STATE STREET CAMPUS GARAGE MADISON, WI 20448

OWNER:	CITY OF MADISON
From ARCHITECT:	EPPSTEIN UHEN ARCHITECTS, INC
To CONTRACTOR	STEVEN'S CONSTRUCTION
DATE OF ISSUANCE:	12/19/2023

This is not a CHANGE ORDER or a DIRECTION TO PROCEED with the work described in the proposed modifications.

7TH & 8TH FLR LIFE
SAFETY PLAN

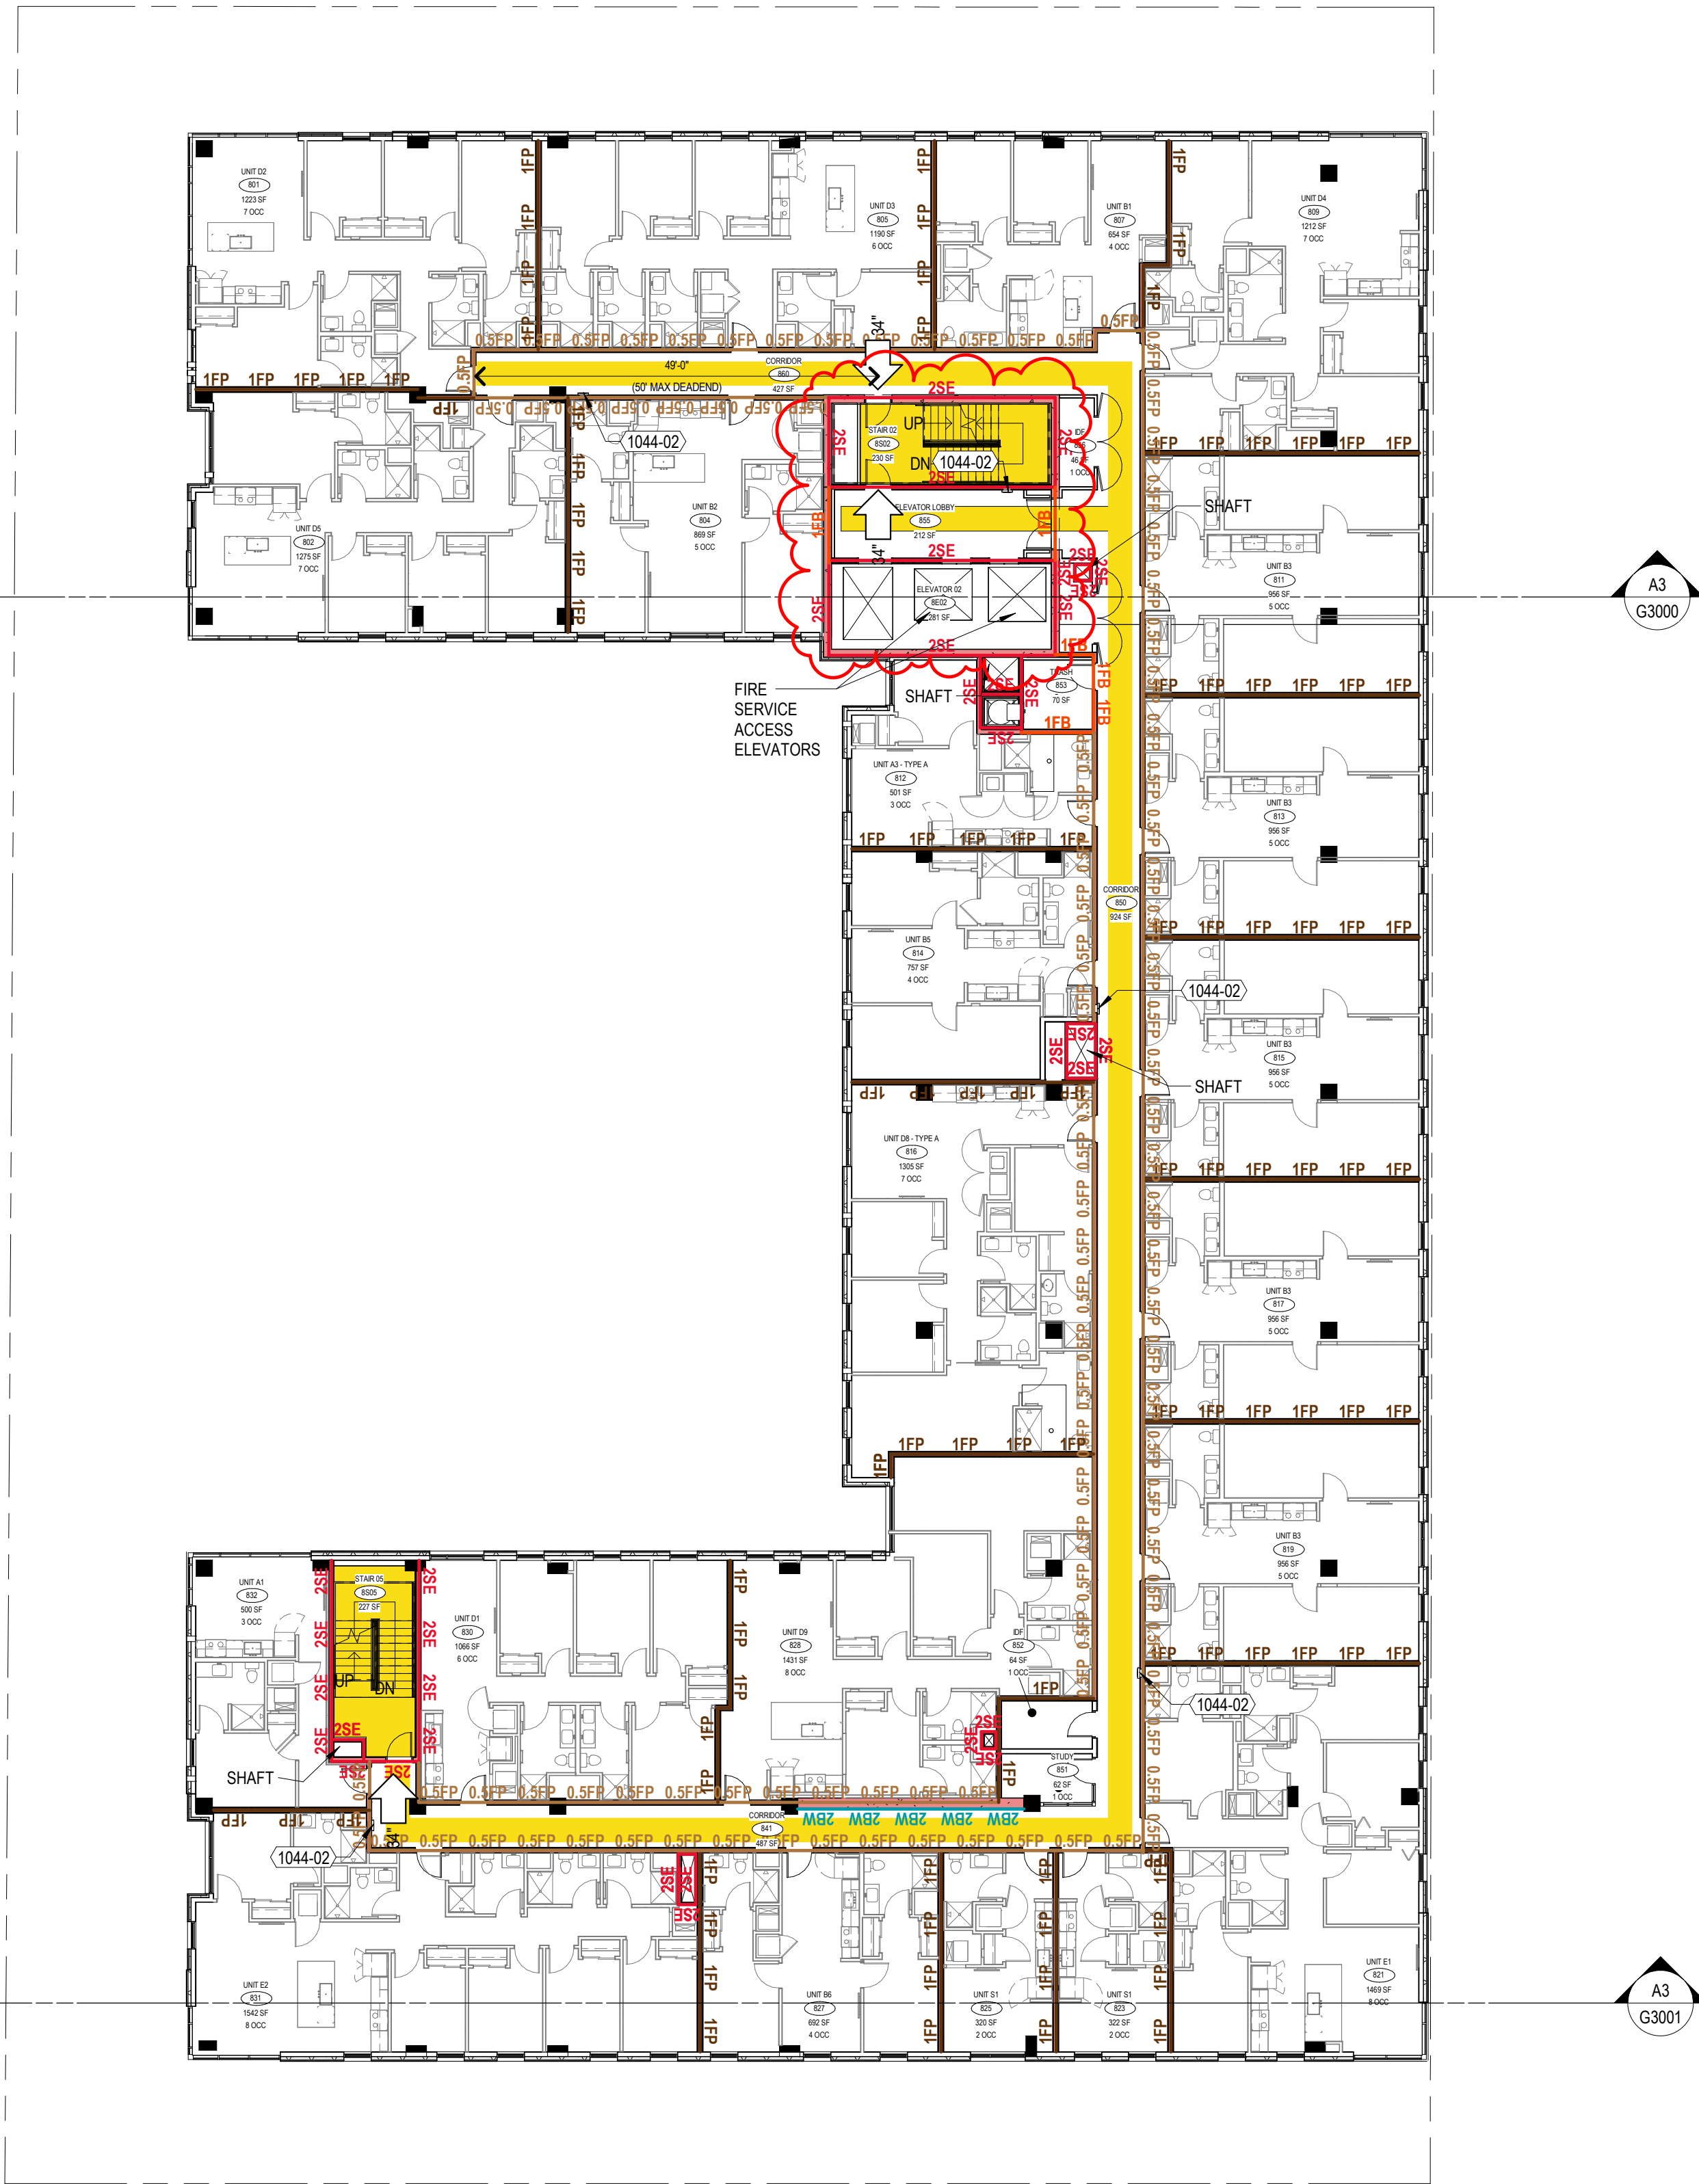
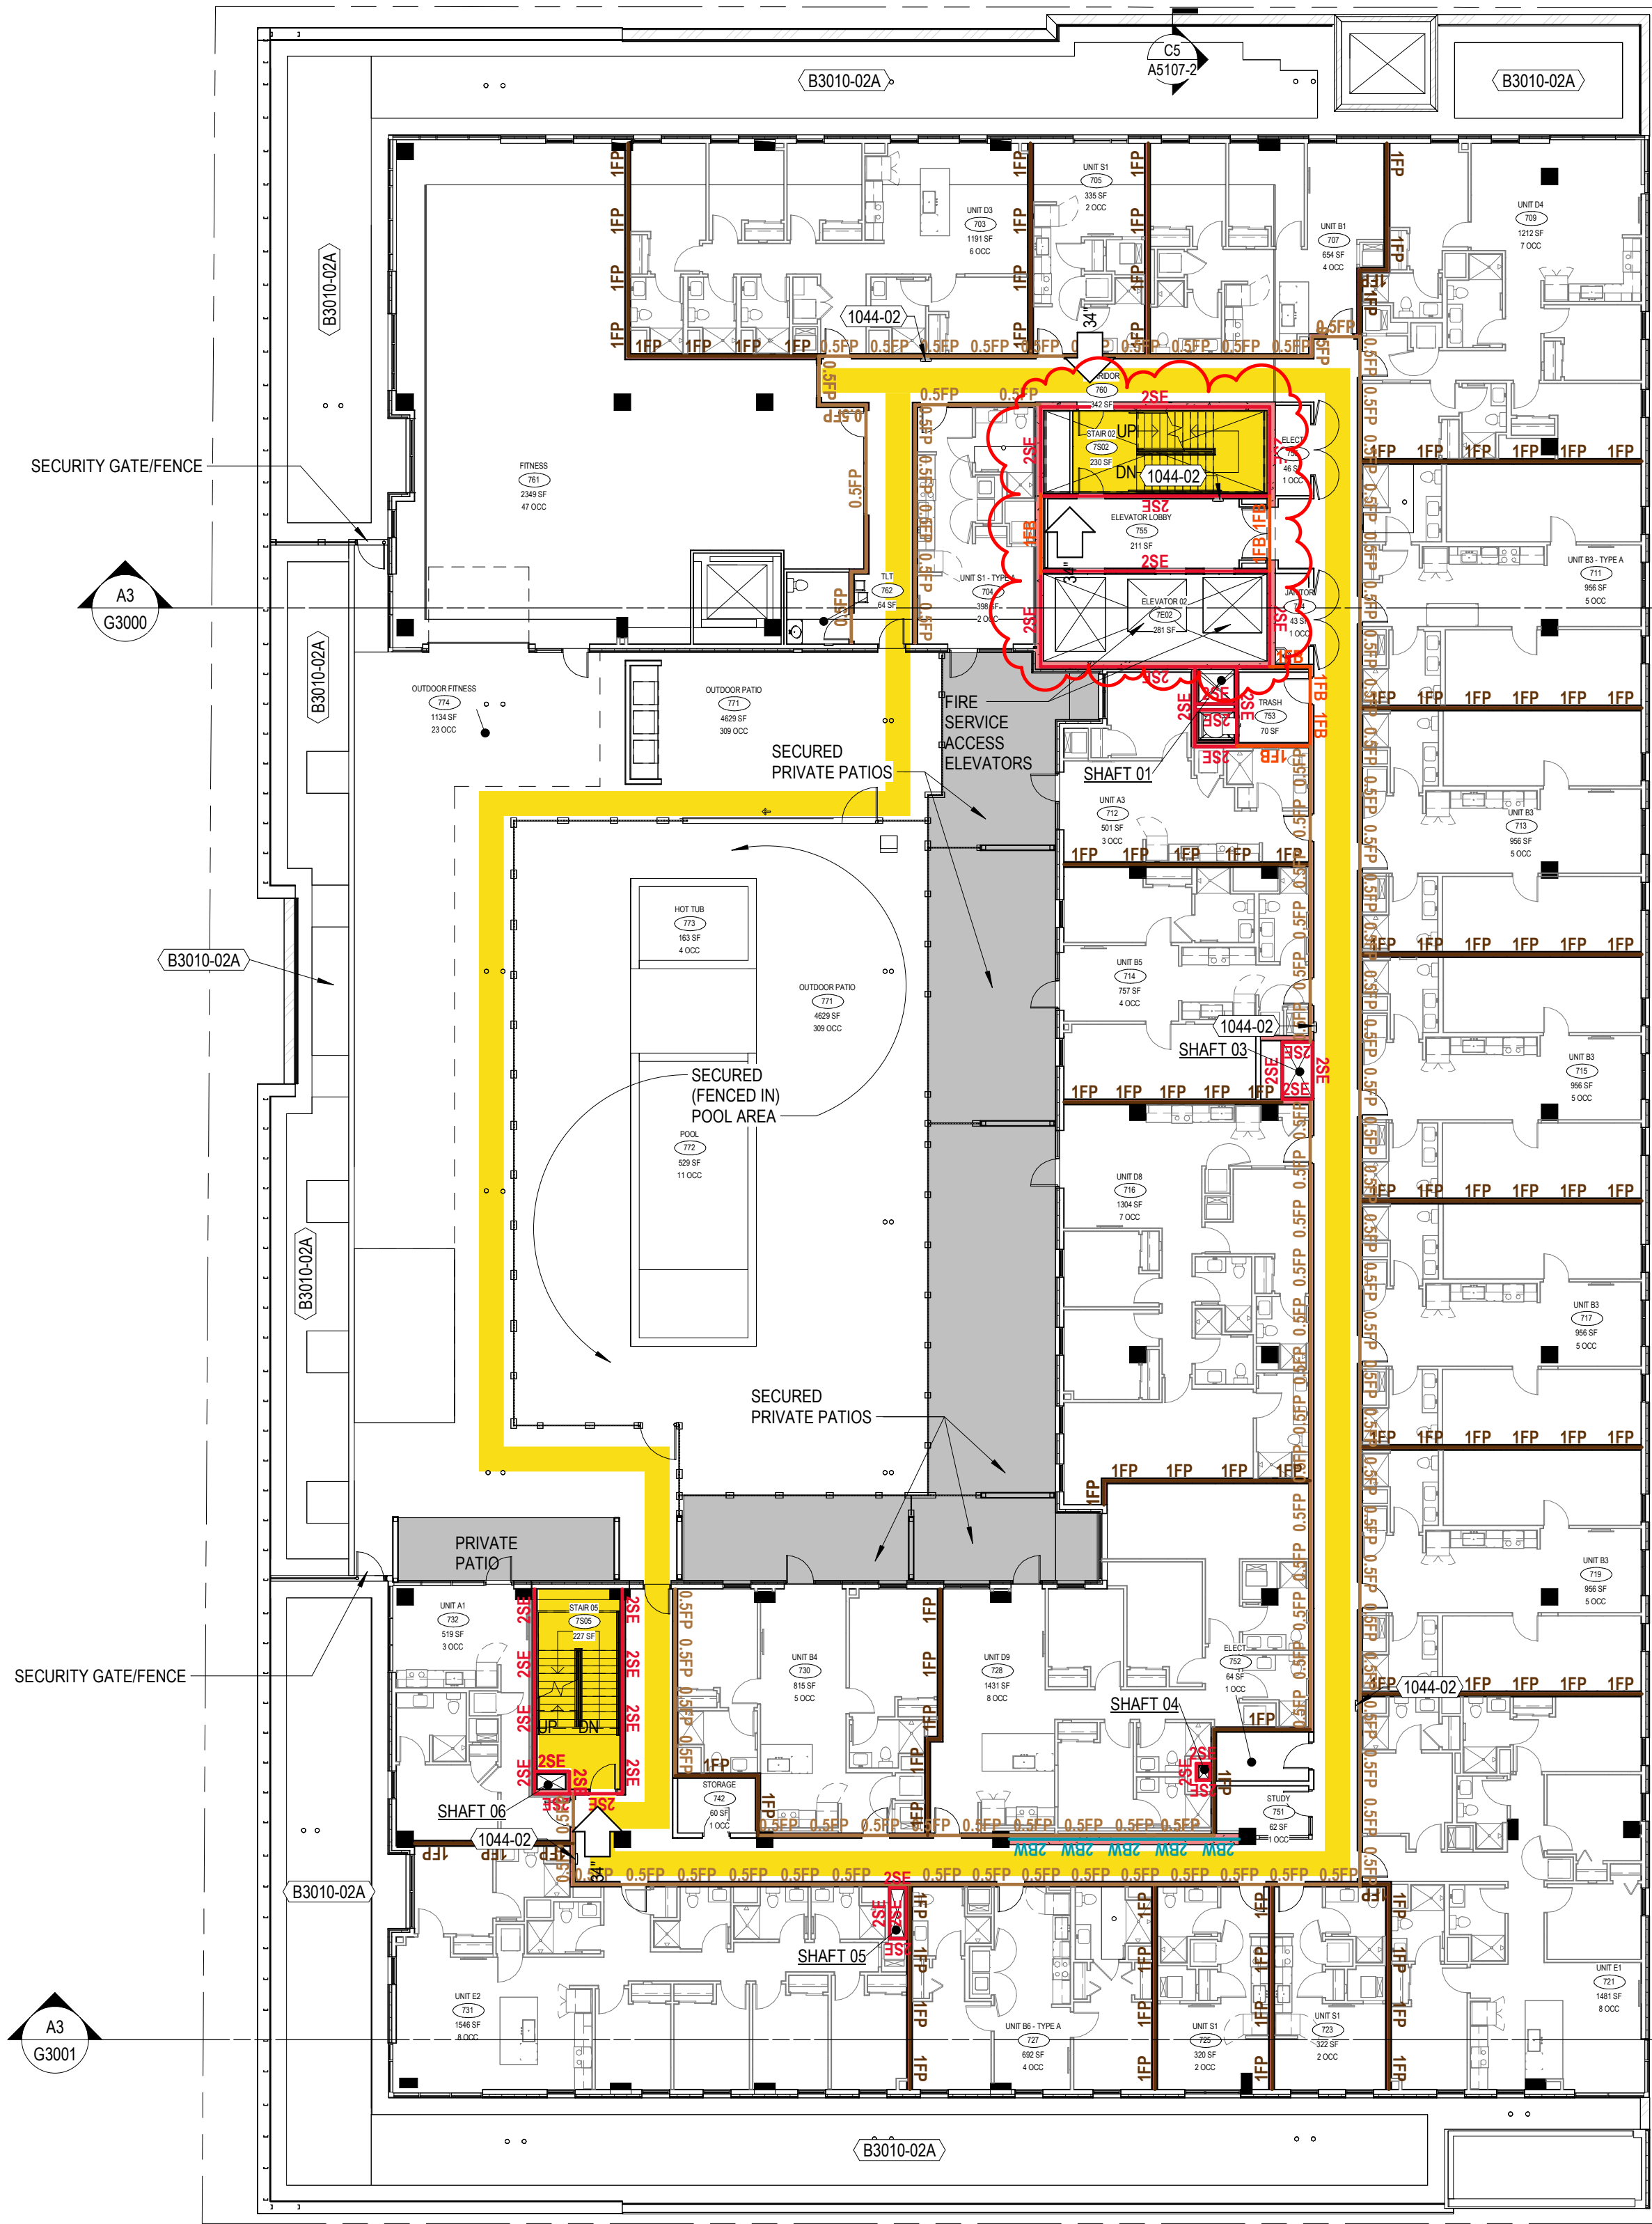
G1004 7TH & 8TH FLR LIFE SAFETY PLAN
REVISE CORE WALLS AT ELEVATOR 02/STAIR 02

GRADING PLAN -
PHASE 1 & 2

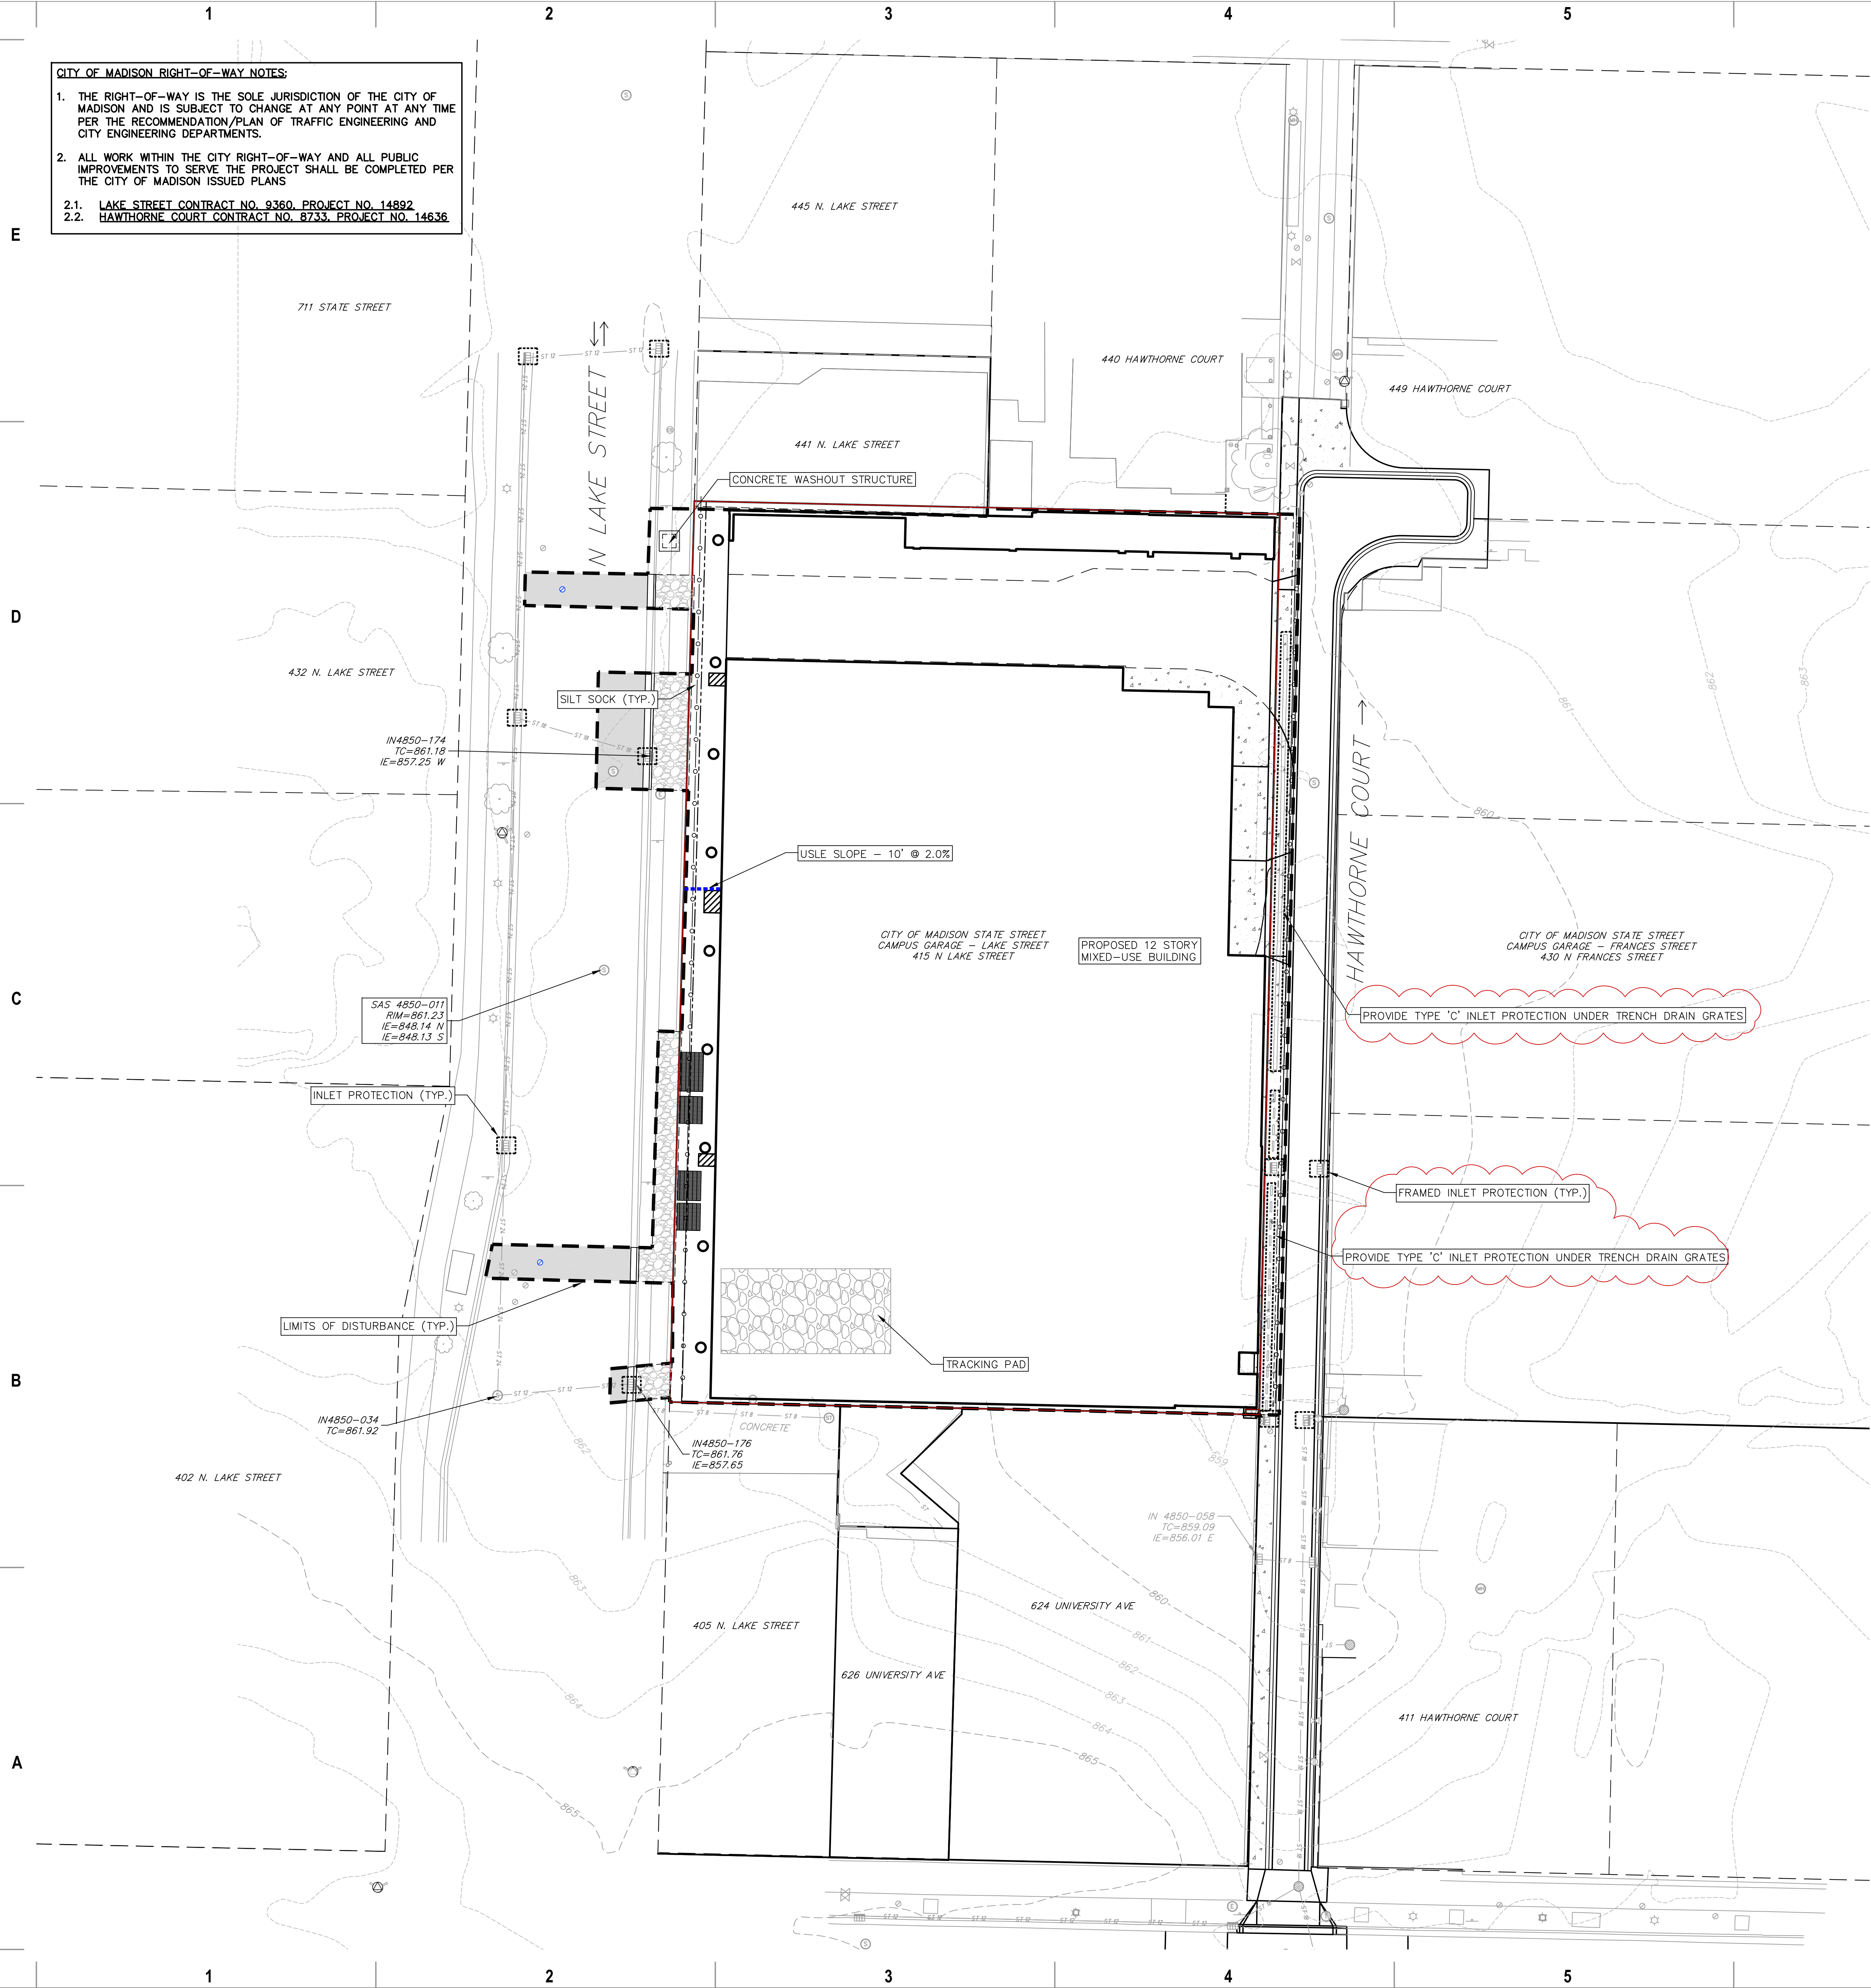
C400 GRADING PLAN – PHASE 1 & 2

REVISE SPOT ELEVATIONS ALONG LAKE STREET SIDEWALK TO REFLECT CITY DESIGN.

ADD DETAIL SPOT ELEVATIONS ALONG BUILDING FAÇADE.

REVISE EXIT SLOPE FROM BUILDING TO PUBLIC WALK AT MAIN FIRST FLOOR ENTRY POINT

ADD LANDING, STEPS, AND HANDRAILS TO NORTHWEST EXIT AT TRANSIT HUB.

ADD SPOT ELEVATIONS AND SLAB SLOPES WITHIN THE BUILDING AT TRANSIT HUB EXIT.

REVISE SPOT ELEVATIONS ALONG HAWTHORNE COURT TO REFLECT CITY DESIGN.

ADD STEP AND RAILING AT SOUTHEAST BUILDING EXIT.

C400 GRADING PLAN - PHASE 1 & 2
REVISE SPOT GRADES/SLOPES ALONG LAKE STREET SIDEWALK AND TERRACE
